SRFB Grant Regional Application Materials

Mill Creek Fish Passage Project

Chelan County Natural Resources Department
411 Washington Street Suite 401
Mike Kane
PRISM # 18-1824

Comments

GRADING PROFILE

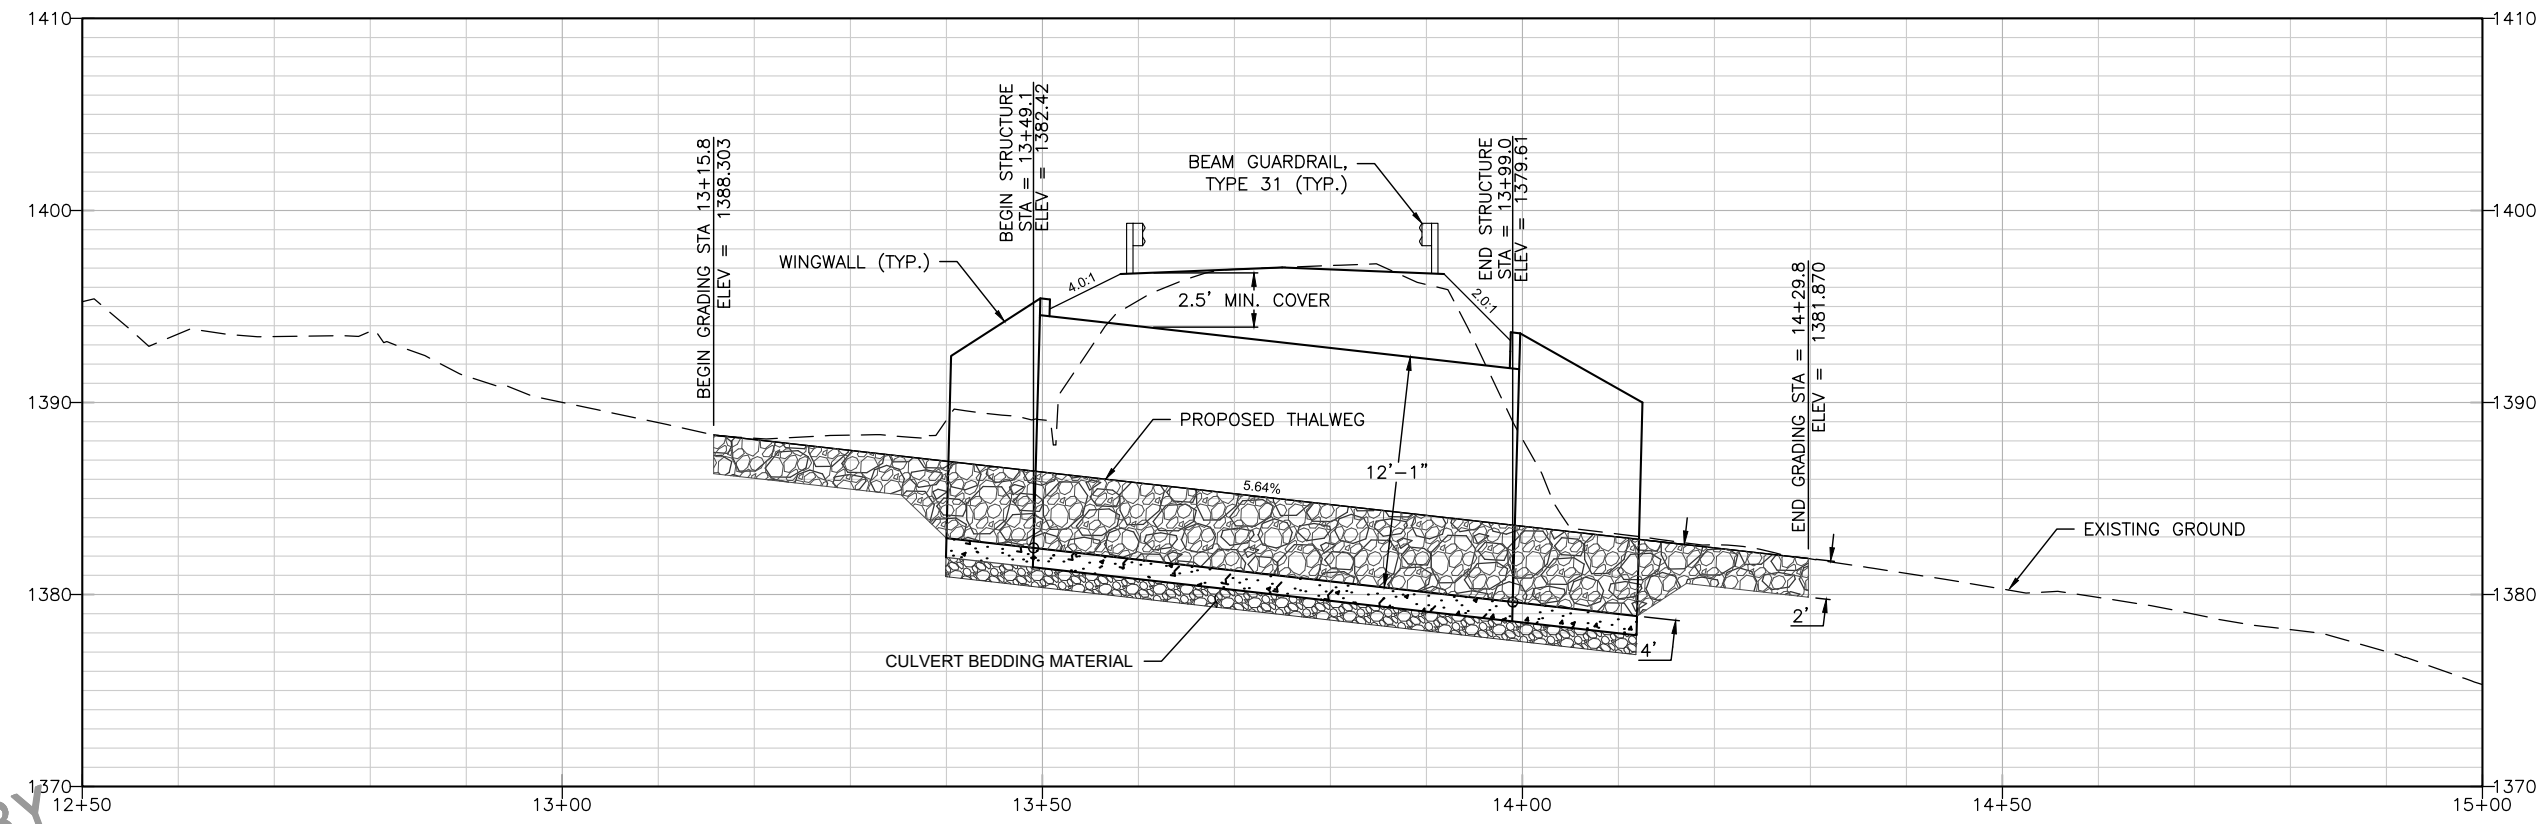
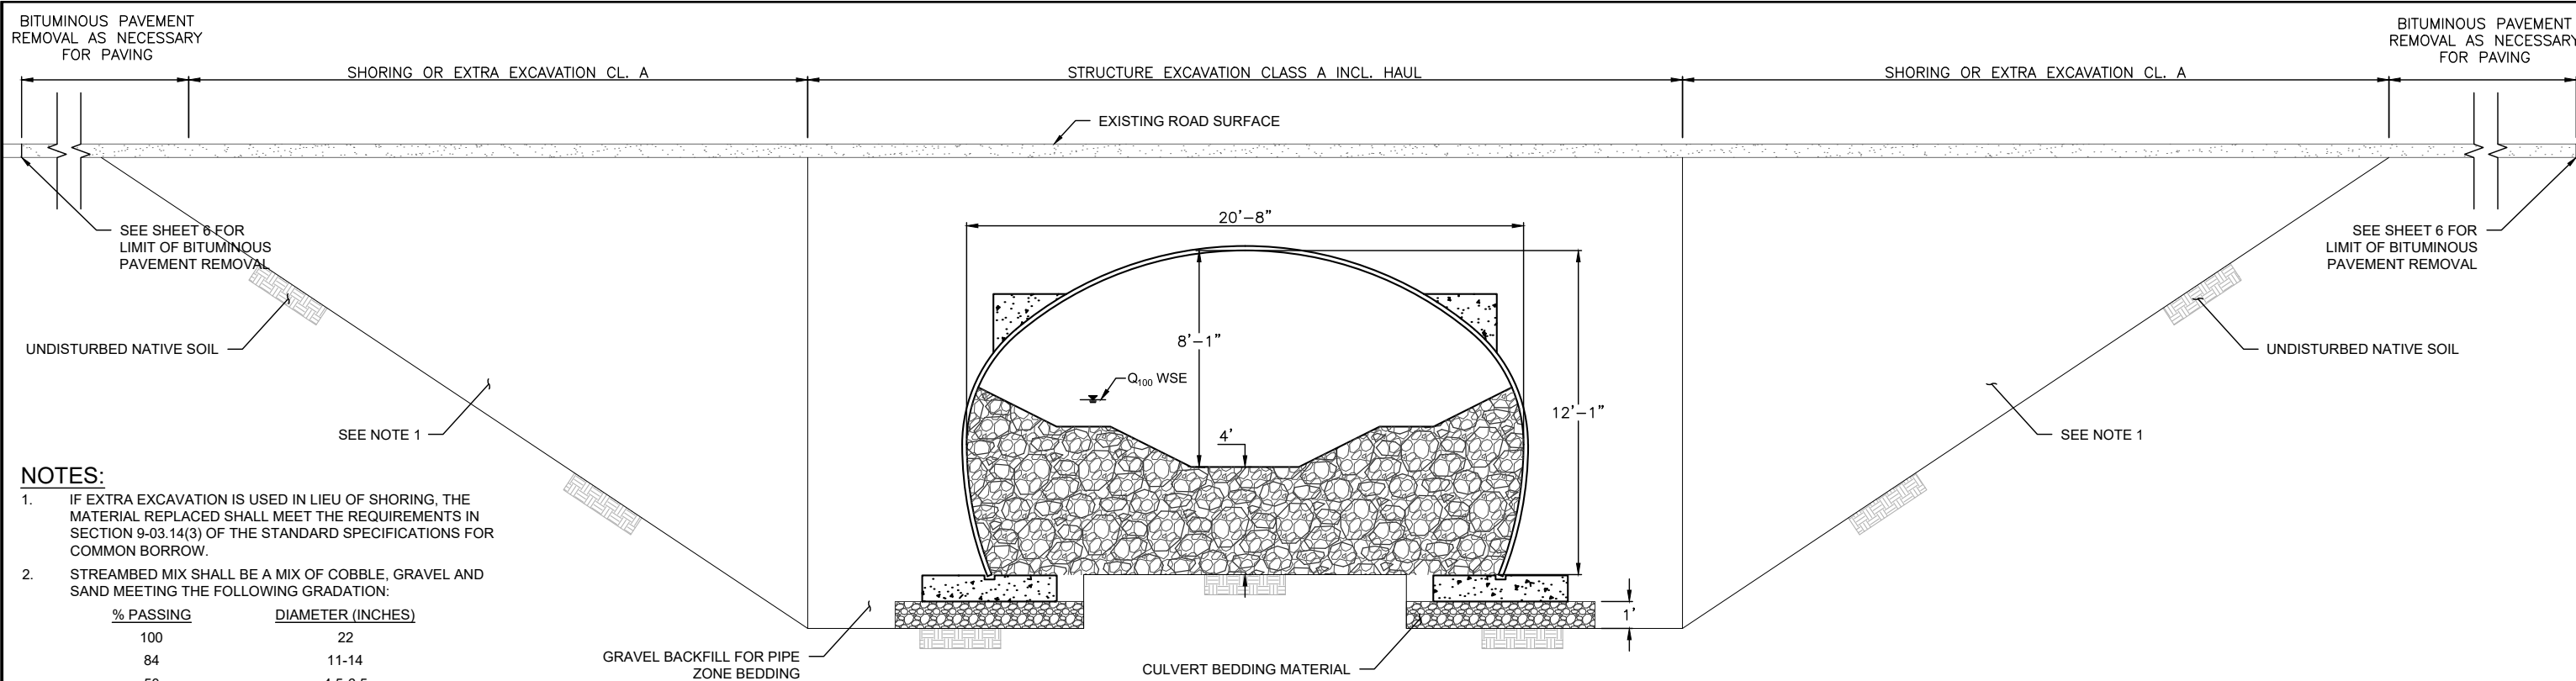
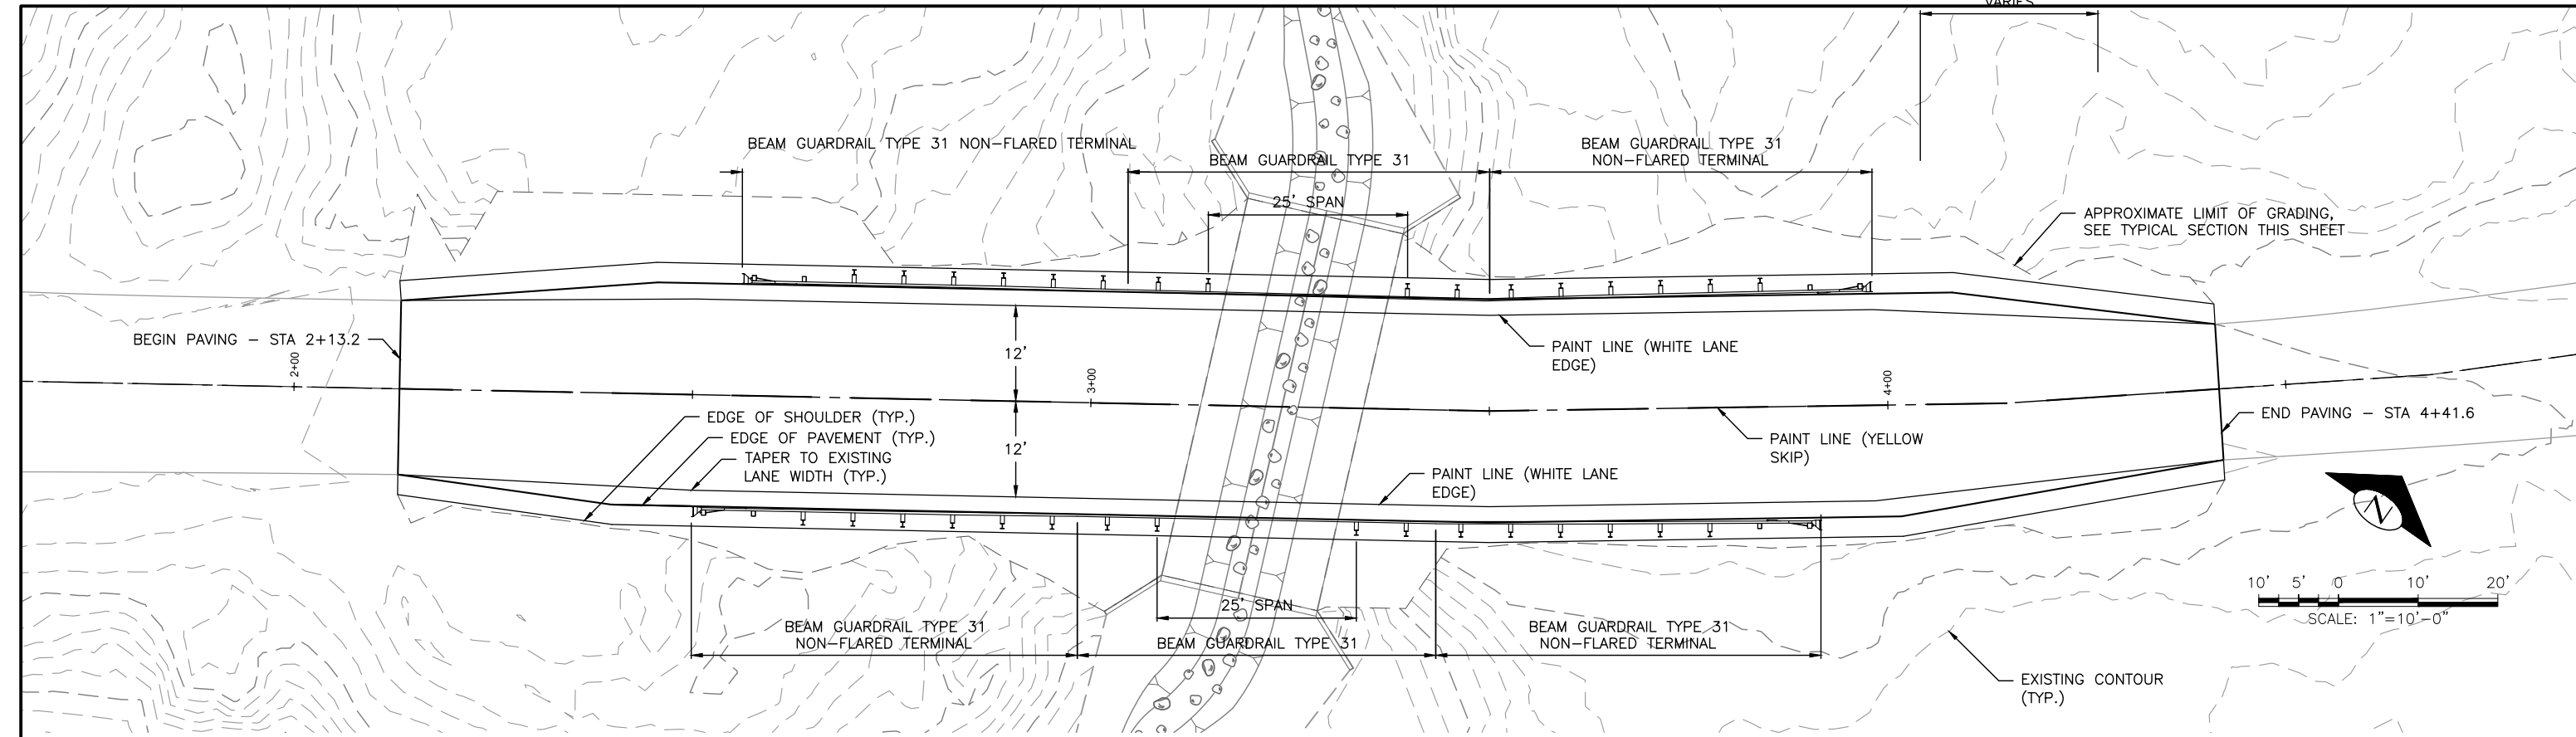
The proposal references "current 30% design"; please load this to PRISM. Preliminary designs and a basis of design (BOD) report that meet the criteria identified in Manual 18 Appendix D will need to be posted on PRISM before final application. The BOD report should include a discussion of the alternatives considered and the rationale for the preferred selection. If this will not be feasible, the grant should be for design and permits, without construction. The cost estimate shows nice detail on construction costs but should also include match and show the total project cost.

The proposal highlights the potential for debris flows to occur in the basin and the increased span and footing depth for the proposed drainage structure to accommodate sediment deposition and minimize scour impacts. While a nearly 21-foot wide corrugated arch pipe with about 12 feet of clearance may accommodate smaller debris flows, most debris flows contain a fair amount of woody debris that typically will plug even the largest of culverts. Increasing the size and clearance of the arch pipe may in this case just be adding costs to the project without providing meaningful protection from debris flows. The project design should focus on maintaining the stability of the crossing and allowing for maintenance access to clean out the structure in the event of a debris flow. The culvert inlet should also be mitered to increase its capacity and lessen the impact of woody debris piling up.

"Figure 5" of this document is the complete set of 30% design plans. 60% preliminary designs have not been completed.

The design team has included total project cost and anticipated match from FBRB for this project, but does not have a completed a basis of design report at this time and does not have current funding to complete prior to the final PRISM submittal. The sponsor has reduced the ask from SRFB to \$131,476 (21%).

The design team is willing to consider various design options including a bridge while completing preliminary designs, but accommodating the concerns of Chelan County Public Works and the adjacent landowner will remain a high priority in that process. The design team is definitely focused on maintaining the stability of the crossing and access for maintenance will be possible post-construction. The sponsor would be willing to work with the SRFB Panel to address debris flow concerns while maintaining a cost effective project.
